Thank you for your July 24, 2002, letter that you hand delivered to Mr. Nicholas Artimovich of my office on October 23, 2002. In that letter you are requesting Federal Highway Administration (FHWA) acceptance of your company's 8-foot wide Type III barricades using 0.450-inch solid polyethylene plastic panels and X-tube plastic uprights as crashworthy traffic control devices for use in work zones on the National Highway System (NHS). Accompanying your letter was a summary report of crash testing conducted by E-Tech Testing Services and a CD with photos of the tests. You requested that we find these devices acceptable for use on the NHS under the provisions of National Cooperative Highway Research Program (NCHRP) Report 350 "Recommended Procedures for the Safety Performance Evaluation of Highway Features."

Full-scale automobile testing was conducted on your company's devices. Two stand-alone examples of the device were tested in separate tests, one head-on and one turned at 90 degrees, as permitted in our guidance memoranda. The complete device as tested is shown in Enclosure 1.

- To prevent misunderstanding by others, this letter of acceptance, designated as number WZ-136 shall no

ENCLOSURE 2

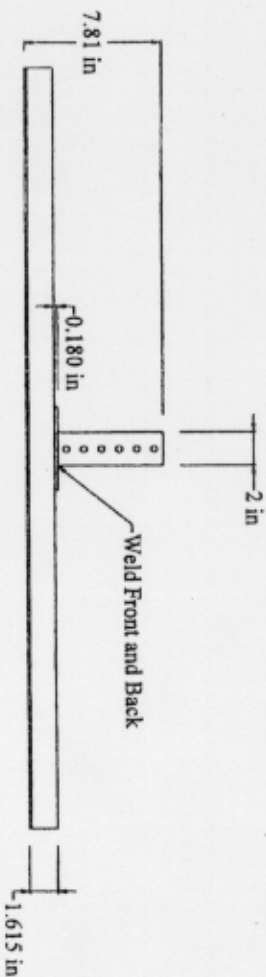
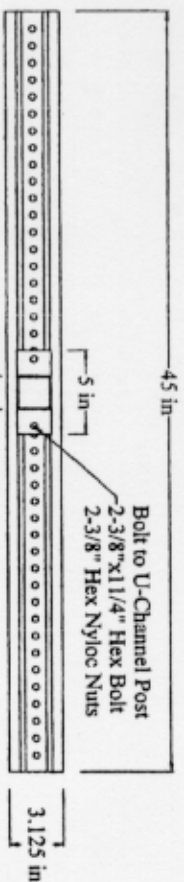
The frame of the barricade consists of 44.5 mm (1.75 inch) square plastic X-tube uprights. The skids are 2 PPF U-channel posts. The socket for supporting the uprights is a 6-inch long piece of 50.8 mm (2 inch) perforated square steel tube welded to a piece of 7 ga flat steel. The flat steel piece is drilled to accommodate bolts used to attach the socket to the skid. The uprights are

simply inserted into the socket. The barricade rails measured 2438 mm long by 203 mm high by

11.4 mm thick (8 feet by 8 inches x 0.14 inch) polyethylene board. The entire barricade (without ballast or lights) weighs 32.8 kg (72.3 pounds.) Each barricade also had two lightweight warning lights mounted to the top of the upright.
